DK Global Fashion Wear Ltd.

H#330/1, West Souldubi, Kashimpur, Gazipur

17 July 2023

Observation

Observation: Building-1 (Production Building)

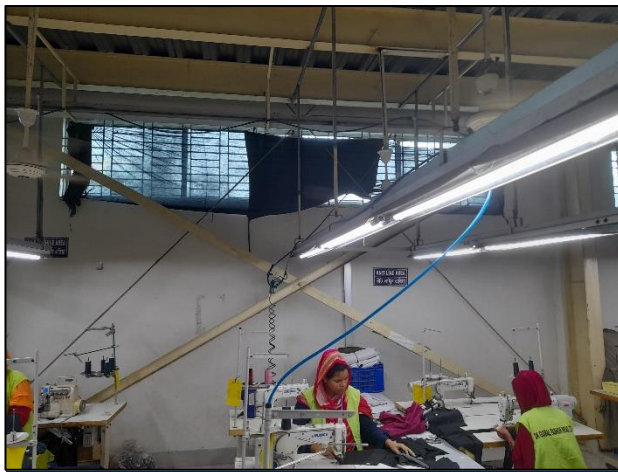
Lack of lateral stability system

Roof & wall bracing provided

Compression strut missing in gable frame

Roof and wall bracing were provided at some location. However, compression strut was missing in gable frames to transfer the lateral load therefore lateral stability system of the shed is apparently incomplete. Building engineer is required to check the lateral stability system of the structure and suggest necessary remedial actions accordingly.

Bracing layout plan

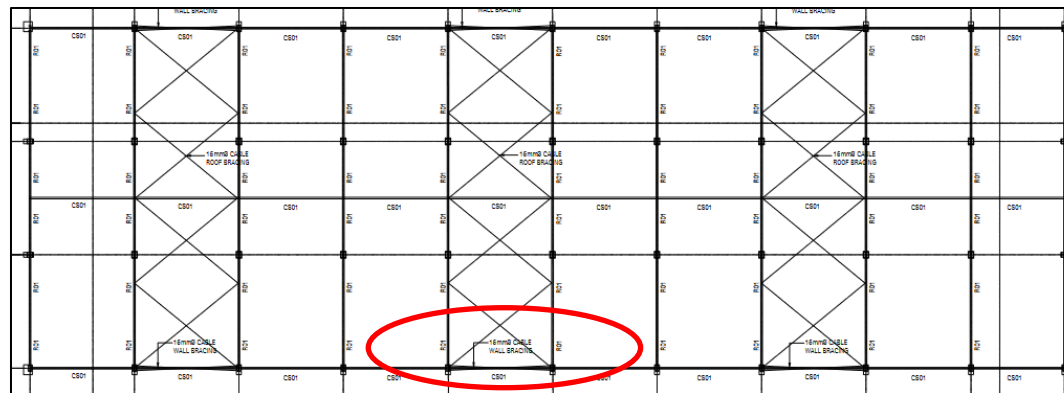
Lack of information in as-built drawing

Angle bracing (Ground Floor)

Cable bracing (1st Floor)

Roof bracing

In bracing layout plan, only horizontal and vertical cable bracing was shown. However, no information was available regarding vertical angle bracing on ground floor. In addition, elevation view and connection details of bracings were also not present in the as-built structural drawing. The building engineer is required to survey the whole structures and prepare accurate as-built drawings accordingly.

Significant gap in steel connection plates in different location

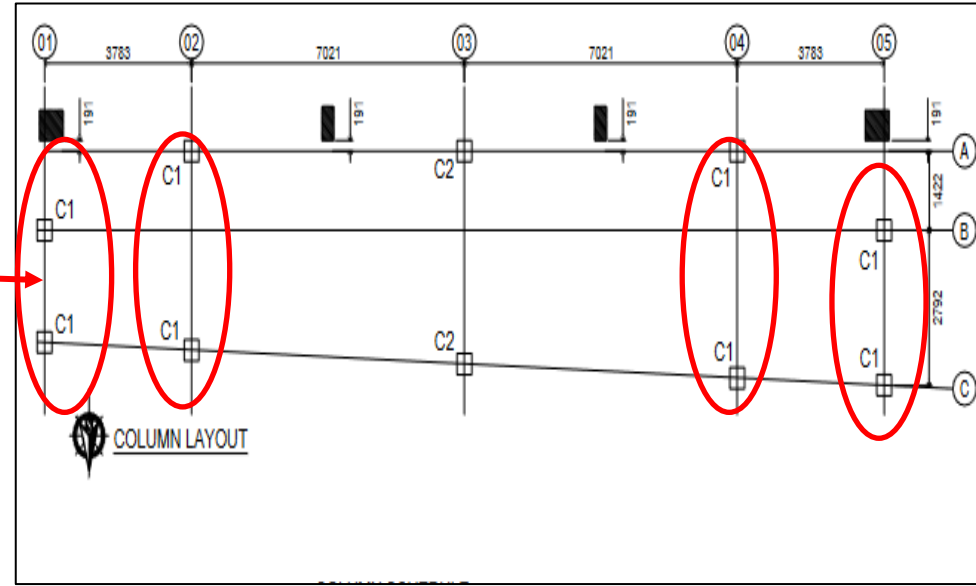
Significant gap in connection at several location

Significant gap in steel connection plates of rafter & column was found at different locations of the structure. Building engineer is required to survey the whole structure & identify the locations of the connection gaps. Factory engineer is also required to assess the reason of connection gap & provide proper remediation. Factory is required to follow recommendation of remediation suggested by the engineer.
